5. Birch Forest No. 3; KPB File 2022-151R1 Edge Survey & DesignPoppin Family Revocable Community Property Trust Location: Erlwein Road, Erlwein Circle, Smith Road & Shishmaref Drive Sterling Area

ITEM #5 - PRELIMINARY PLAT Birch Forest No. 3 Phase 1

KPB File No.	2022-151R1
Plat Committee Meeting:	April 22, 2024
Applicant / Owner:	Poppin Family Revocable Community Property Trust of Soldotna, Alaska
Surveyor:	Jason Young, Mark Aimonetti / Edge Survey and Design, LLC
General Location:	Erlwein Road, Sterling

STAFF REPORT

BIRCH FOREST No. 3 PHASE 1

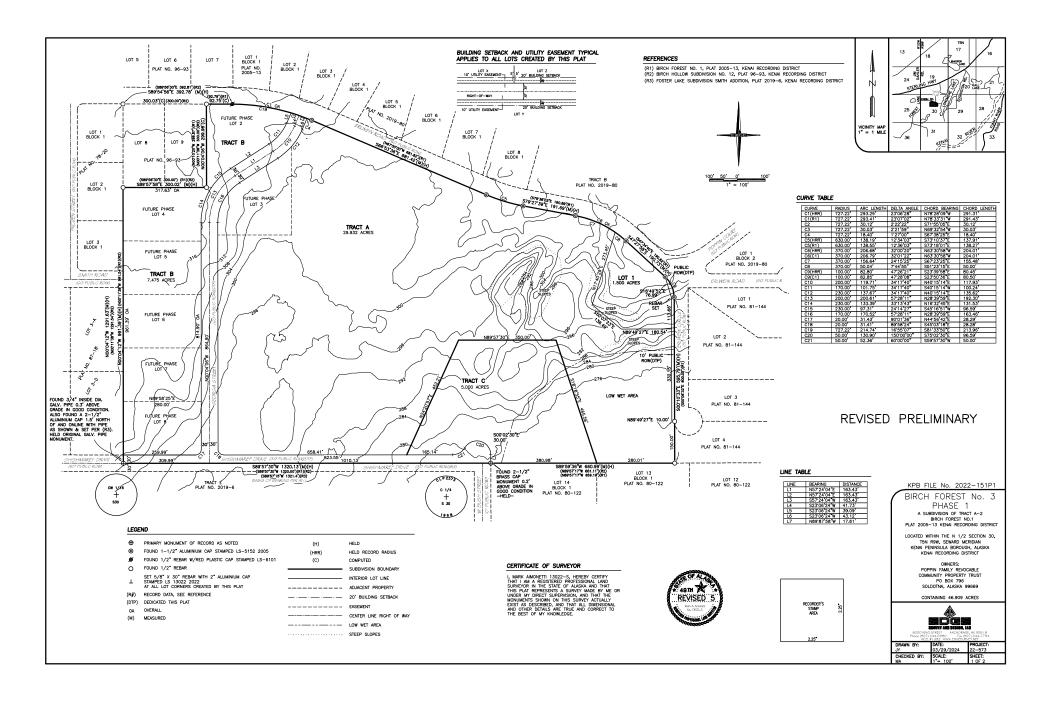
Correct KPB File No to 2022-151R1

Show the setting of a monument at the southwest corner of the dedication of Erlwein Circle.

Show setting of monuments along Georgia Street and Shishmaref and Tract C and Lot 1 Tract C linework is too dark, match interior lines of lot 1.

Lot 12 to southeast needs Blk 2 added
